STAFF REPORT
COMMUNITY DEVELOPMENT DEPARTMENT

HEARING DATE: 8/11/2020
 TO: Mayor & City Council
 FROM: Joe Dodson, Associate Planner
 208-884-5533
 SUBJECT: H-2020-0035
 Poiema Subdivision
 LOCATION: The site is located at 3727 E. Lake Hazel Road, in the NE ¼ of the NW ¼ of Section 4, Township 2N., Range 1E.

Annexation & zoning of 14.87 acres of land with an R-15 zoning district and preliminary plat consisting of 48 building lots and 6 common lots, by Dave Evans Construction.

B. Master Development Concept Plan

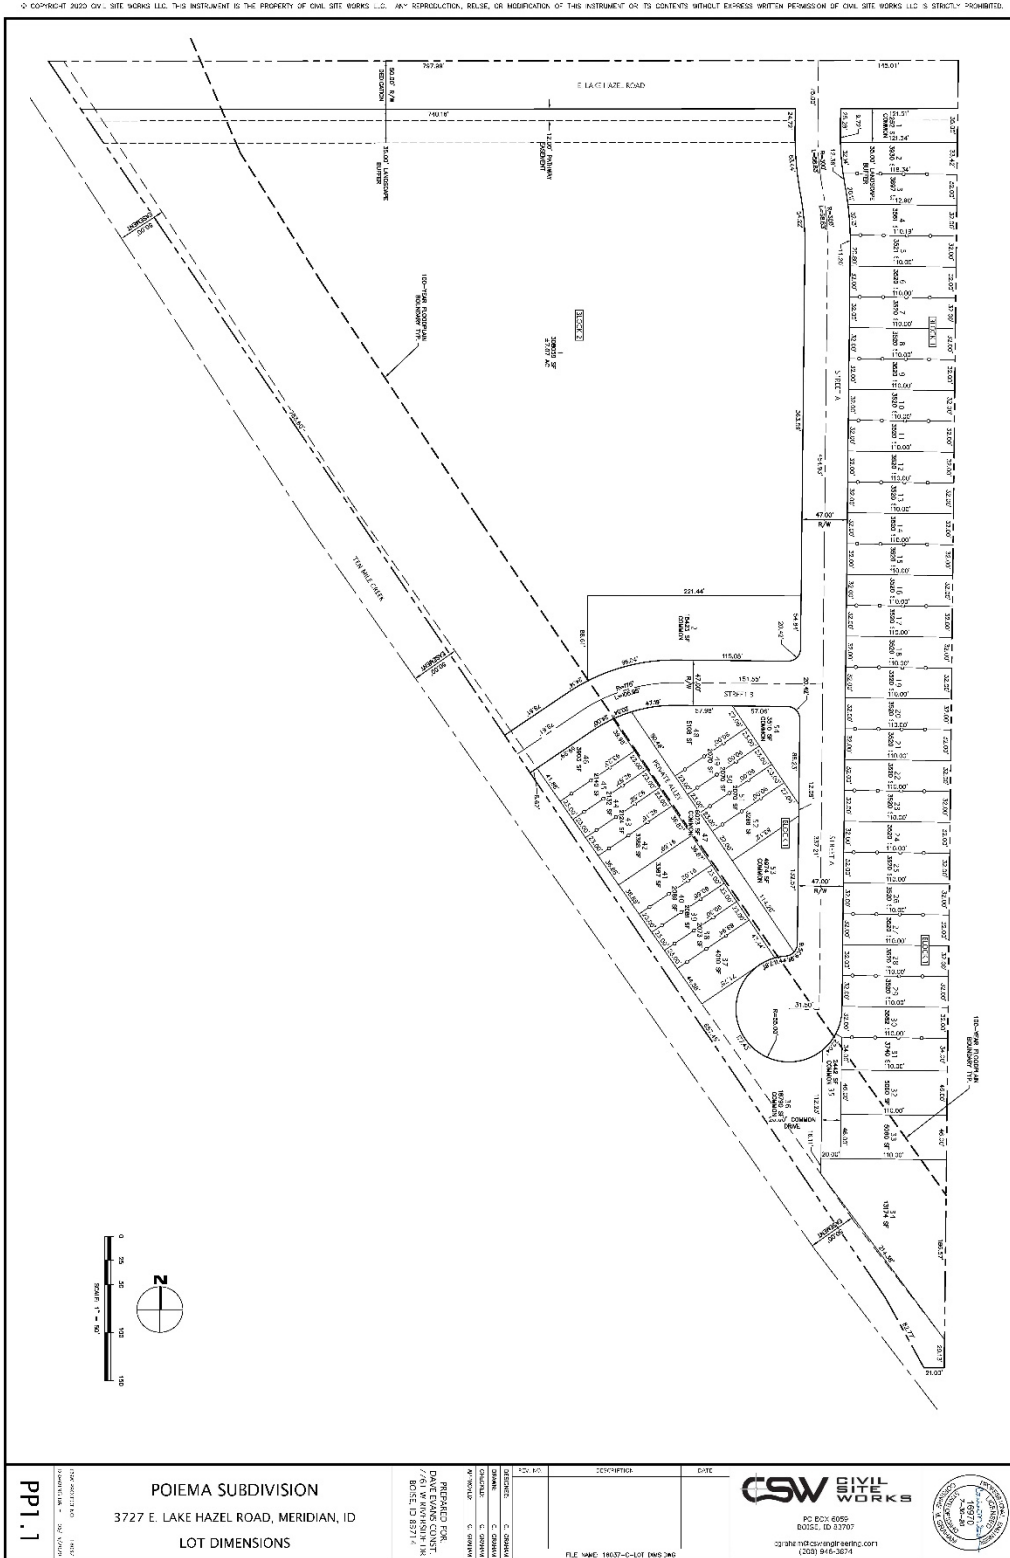
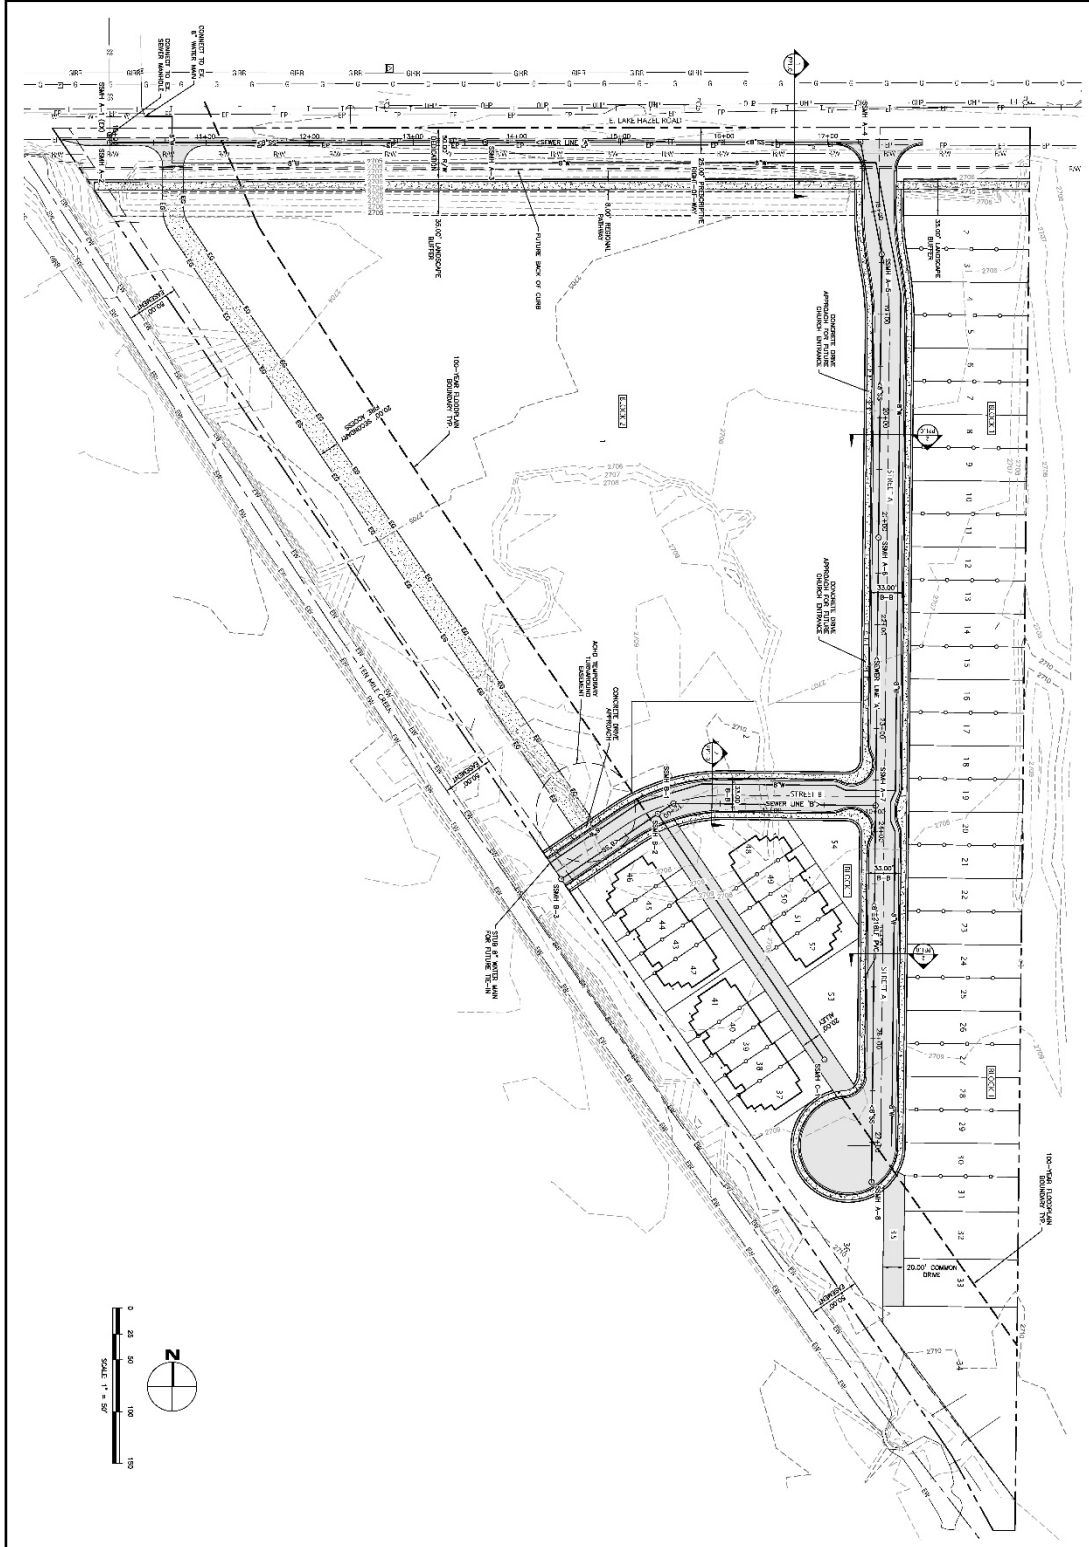
Because the stub street to the west will likely lead to nowhere at the time of this development, the Applicant will have to provide an emergency only access. The Applicant is showing on their master plan (as shown in Exhibit VII.B) a 20-foot wide emergency only access from the stub street that runs along the western property boundary and connects to E. Lake Hazel. ACHD and Meridian Fire Department have granted their approval of this emergency access. Without this

access, this property will be limited to no more than 30 homes until such time that the emergency access is constructed. To remediate this, Staff is recommending the emergency access is built prior to the Applicant receiving any building permit approval.

D. REVISED Plat (dated: 06/15/2020-7/30/2020)

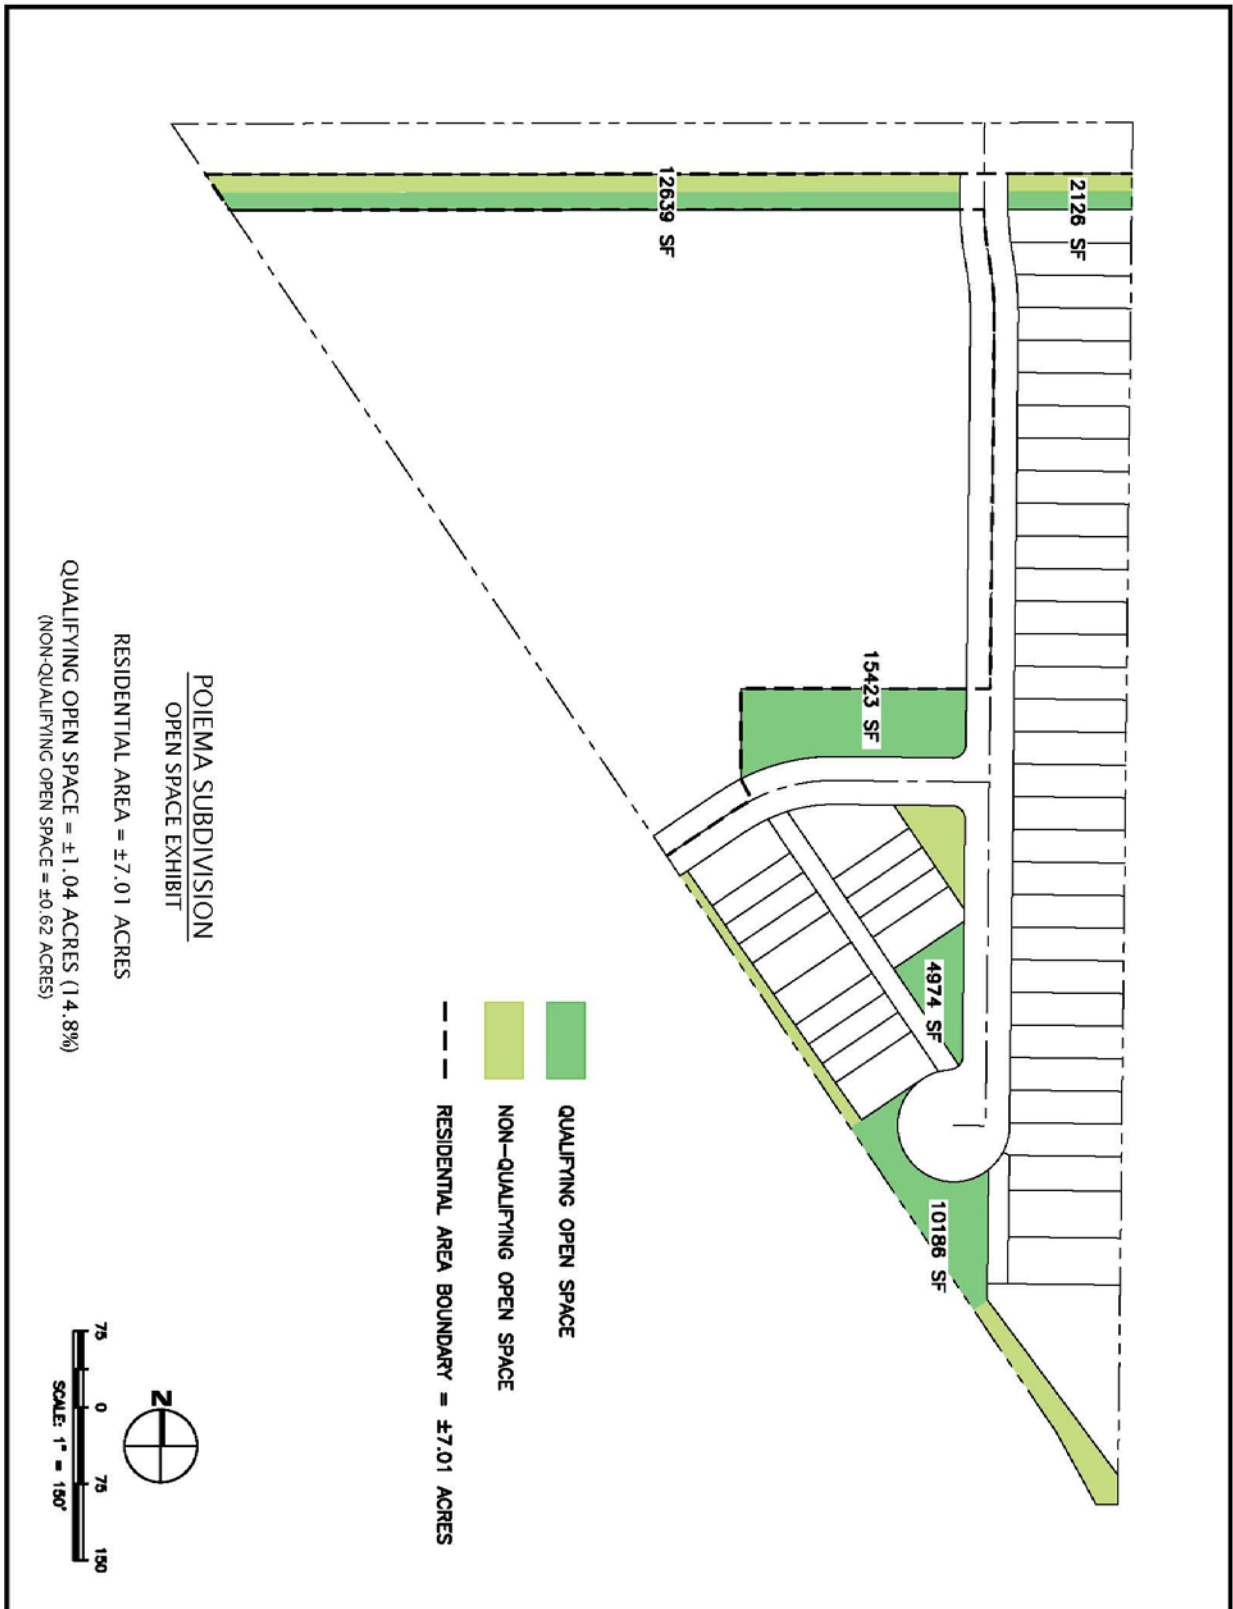
The revised preliminary plat shows a private alley that connects to the future western stub street and the proposed cul-de-sac. As stated above, Staff is unaware of ACHD's formal approval of this location but has also not been given notice of its denial. The Applicant should continue working with ACHD to ensure the location of the alley meets all ACHD requirements. The proposed alleyway is shown as 20 feet wide which meets UDC and Fire requirements; the alleyway will be deemed as a no parking zone for its entirety. Staff supports this alleyway and the alley loaded type of home for this development.

On the revised open space exhibit (Section VII.E) there is an area less than 5,000 square feet located between the alley and the local street. UDC requirements state that in order for this area to be qualifying it must be at least 50’ by 100’ in dimension. Staff uses their discretion when the open space area can meet the 5,000 square foot area requirement but may not meet the precise dimensions above. In this case, this area meets neither of these benchmarks and Staff believes it is not qualifying open space. With this area removed from the open space calculations, Staff has calculated that the qualified open space for the site is approximately 0.64 acres, or approximately 10.57%. The proposed open space still meets UDC minimum requirements and Staff finds that the open space with the water feature and the large open space lot in the center of the development are sufficient for the number of homes proposed in this development.

2. At least (10) days prior to the City Council hearing, the Applicant shall submit conceptual building elevations of the proposed townhome units.
 3. ~~Ten (10) days prior to the City Council hearing, the~~ The preliminary plat included in Section VII.C, dated 04/15/2020, shall be revised as follows:

- a. ~~Add a note prohibiting direct lot access via E. Lake Hazel Road.~~
 - b. ~~Show Lot 34, Block 1, to include that common open space area outside of its fence, adding it to this lot and removing it from any common lot to eliminate a potential safety and crime hazard.~~

E. Open Space Exhibit (dated: 06/15/2020-August, 2020)

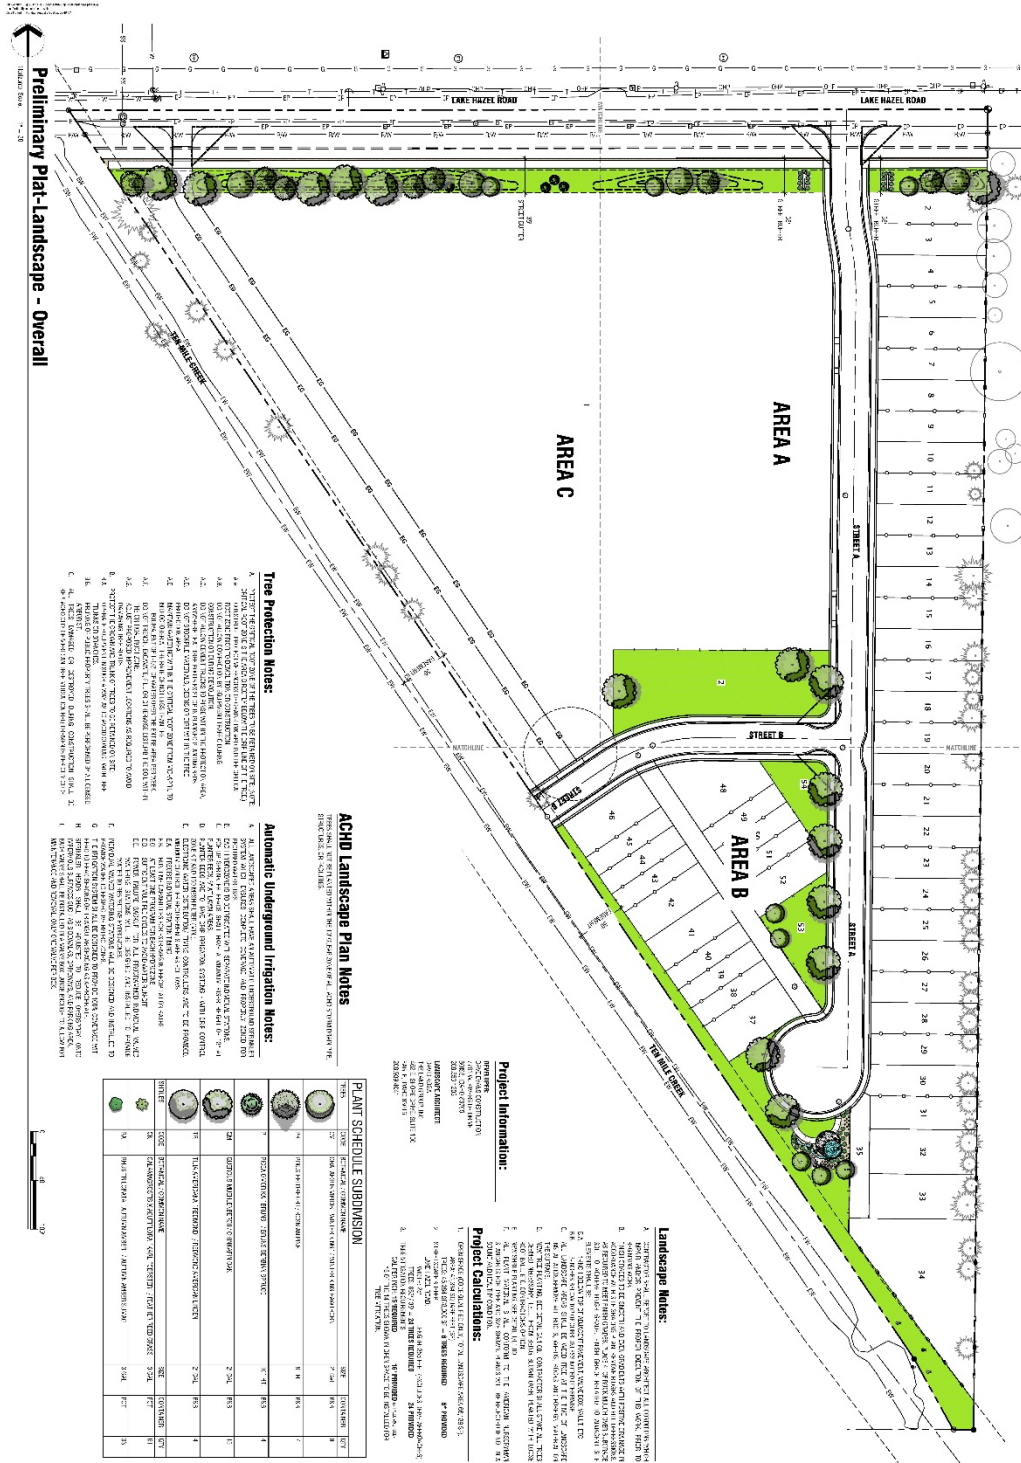
The required landscape buffer along E. Lake Hazel should be shown on the open space exhibit even though it is not qualifying open space. As stated above, Staff recommends these improvements be completed with development of the residential portion of the site. The open space exhibit should be revised to show this area to give a more complete picture of all open space on the site in accordance with UDC 11-3G-3.

5. ~~Ten (10) days prior to the City Council hearing, the open space exhibit included in Section VII.E shall be revised to show the required 35 foot landscape buffer along E. Lake Hazel and show this area in the calculations table.~~

F. Landscape Plan (date: 4/3/2020-8/03/2020)

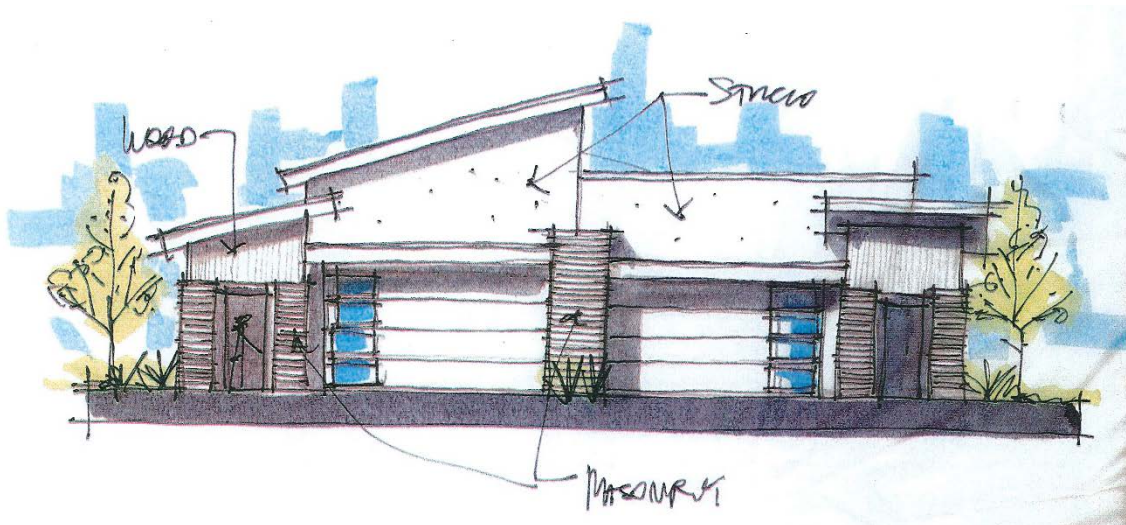
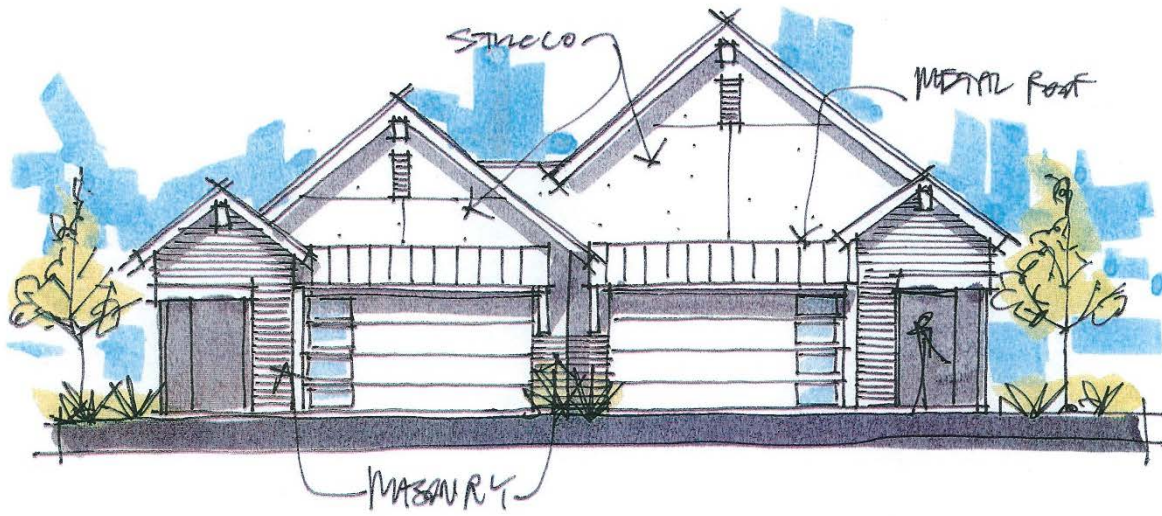
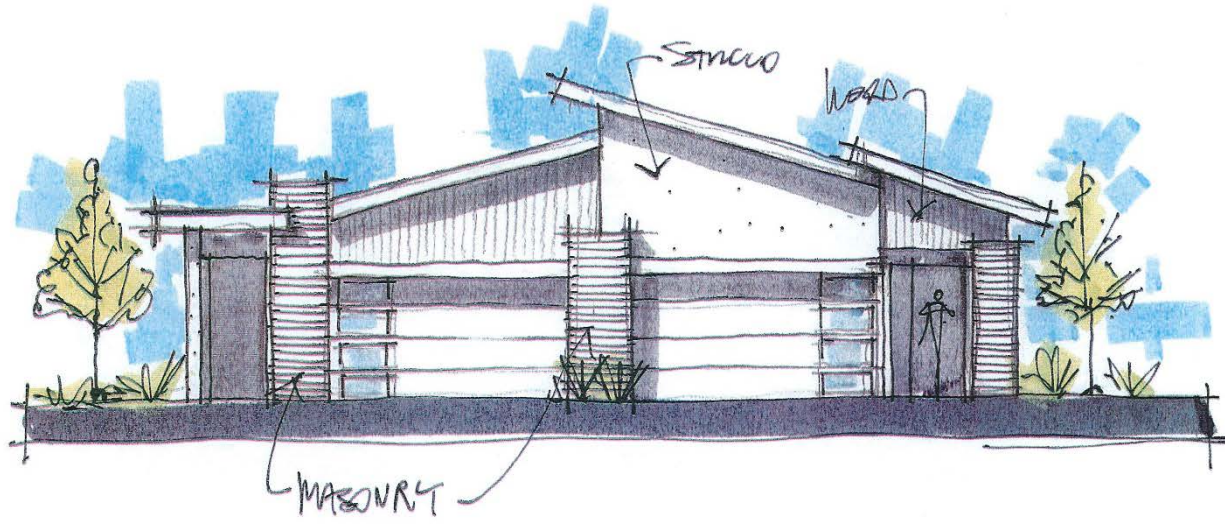
Also shown on the landscape plan is an area directly to the west of Lot 34, Block 1 that is within the Ten Mile Creek easement. This area of the development is not open on both ends and does not offer easy visibility. Staff is concerned with potential safety and crime issues in this small area. UDC 11-3G-3D.3 states that "common open space shall be located in areas of high visibility to avoid hidden areas and corners..." This area is not qualifying open space because it is not open on both ends but it is still common open space and must adhere to these standards. Therefore, Staff is recommending a condition of approval that this area be part of Lot 34, Block 1 to alleviate this potential safety issue. In addition, the Applicant is proposing an additional 8 trees in order to mitigate trees that are being lost with the development of this site. This note is stated on the submitted landscape plan.

All fencing is required to comply with the standards listed in UDC 11-3A-7. Fencing is shown on the landscape plan but is not made clear as to what type of fencing it is. Fencing shown next to any open space shall be open-vision or semi-private fencing per UDC requirements.

4. ~~Ten (10) days prior to the City Council hearing, the~~ The landscape plan included in Section VII.F, dated 05/04/2020 shall be revised as follows:

- a. Label and depict the type of fencing proposed throughout the development; all fencing shall comply with the standards listed in UDC 11-3A-7.
 - b. ~~Revise the landscape plan to show the new layout and townhome units; any changes in landscape calculations shall also be reflected in the calculations table.~~

- c. ~~Correct the landscape buffer along E. Lake Hazel to show the required 35 foot buffer width in accordance with the dimensional standards for R-15 zoning district, UDC 11-2A-7.~~
